PLANNING & ZONING CASE NO. SP2022-054

PROJECT NUMBER:	SP2022-054	CASE MANAGER:	Bethany Ross
PROJECT NAME:	Amended Site Plan for Snuffers	CASE MANAGER PHONE:	(972) 772-6488
SITE ADDRESS/LOCATIONS:	568 E INTERSTATE 30	CASE MANAGER EMAIL:	bross@rockwall.com

TO:	Planning and Zoning Commission
DATE:	November 15, 2022
APPLICANT:	Robert Romano
CASE NUMBER:	SP2022-054; *Amended Site Plan for Snuffer's Restaurant & Bar*

DRAWING NO.:
A001

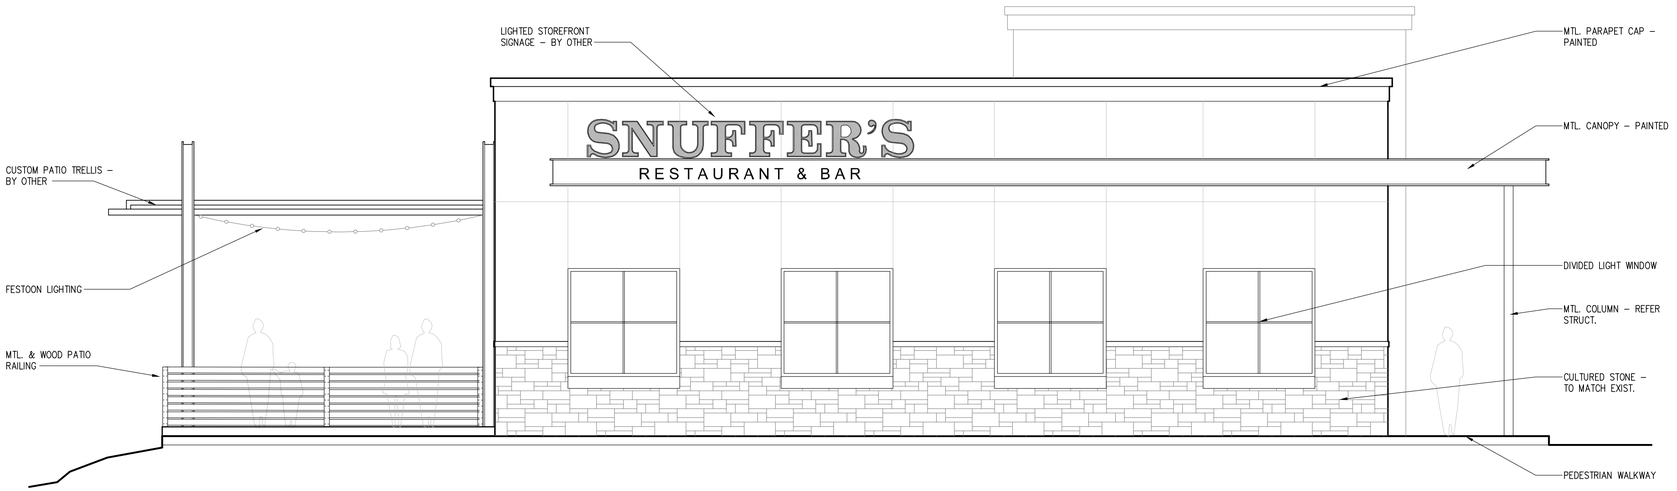
(13) Please review the attached parking agreement. Your existing parking is 49 spaces. The existing restaurant according to RCAD is 2,991.00 SF, which would require a minimum of 30 parking spaces. The proposed expansion of 1,905 SF would require a minimum of 20 parking spaces. This equates to 50 parking spaces required. Please revise parking table.

(14) Is there any proposed roof mounted or pad mounted utility equipment? If so, indicate them on the site plan and building elevations and show any subsequent required screening. (Subsection 01.05. C, of Article 05)

(15) Wood is not permitted as a patio railing. (Subsection 08.04.A, of Article 08)
(16) Please indicate what the service yard is being used for and provide building elevations for this area.

10/19/2022: - No deadend paving. May need bollards or to remove paving.
- What is this in the bathroom area?
- Relocate existing fire hydrant and must replat.
- Move FDC to front of the building so that the side paving can be removed. Or make the FDC remote.

DRAWING NO.:
A300

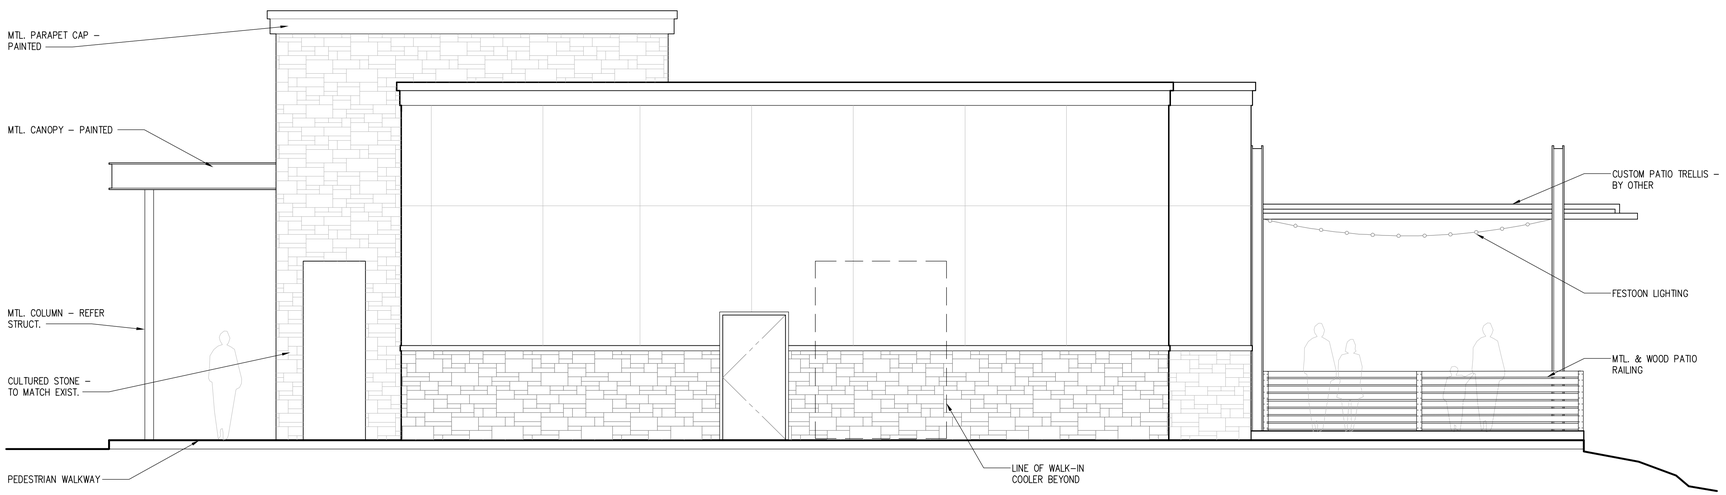
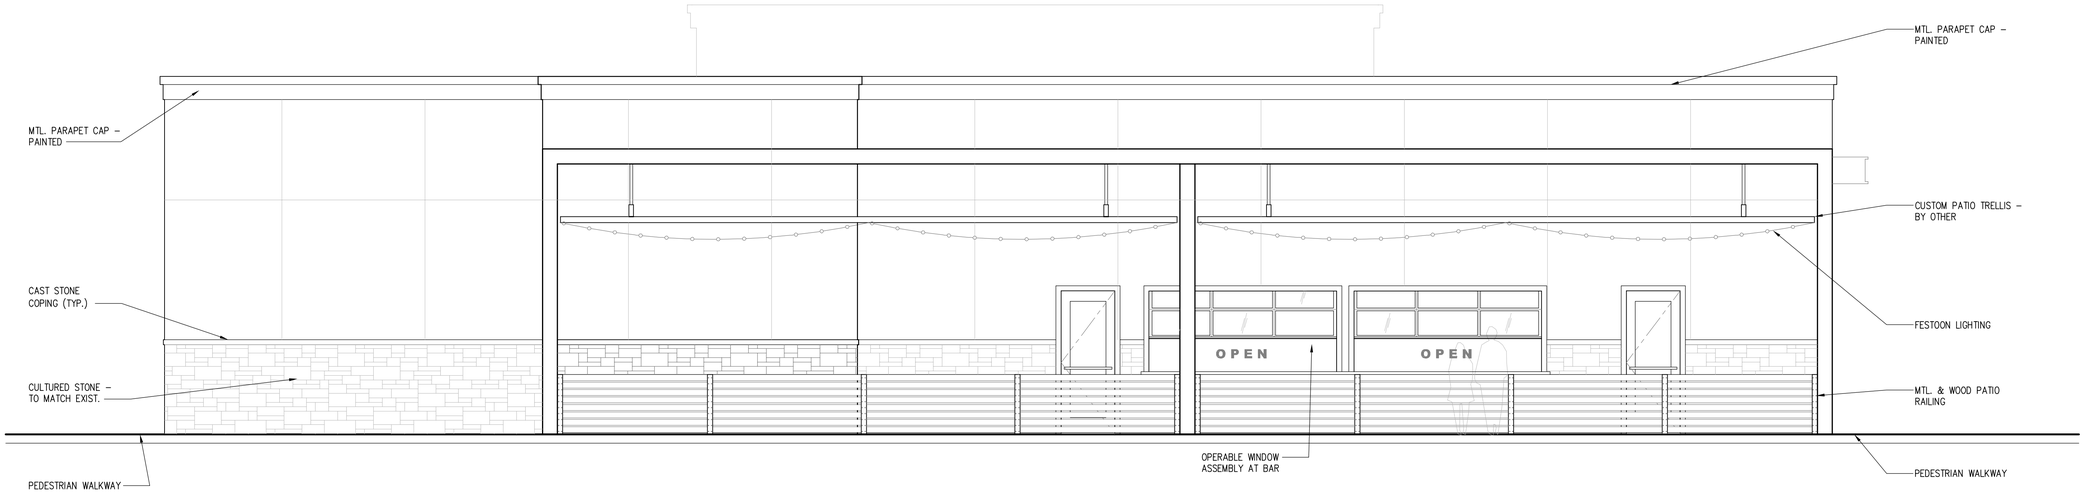
M.11 Building Elevations
(1) Provide the same site data information as the Site Plan.
(2) Please provide a graphic scale. (Subsection 03.04.A, of Article 11)

(5) Provide specifications and description of all proposed building materials. (Subsection 04.01, of Article 05)
(6) Indicate roofing materials and color.
